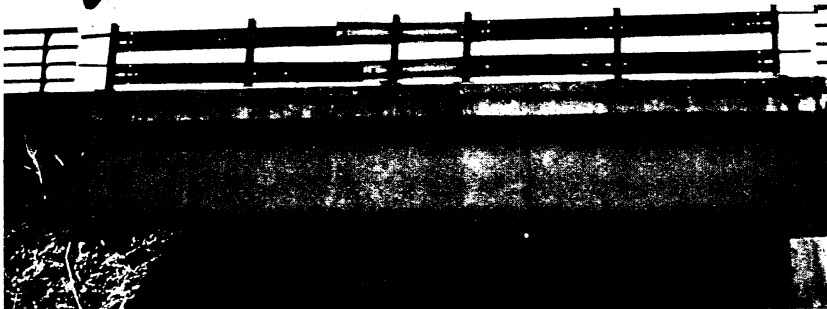
This is also a steel rail and I feel it is a pretty good rail if it was tied together. Here you see it was put up in sections. Now somebody hitting the thing just knocks out two sections and defeats the purpose of the good design in the rail, which is to be solid in the particular case. And I feel that you should go back to these points and maybe run a W-beam right through to provide a sliding action and to protect the rail from damage and keep the cars from smashing into the ends.

I feel we should do this pretty soon, because what are we waiting for?
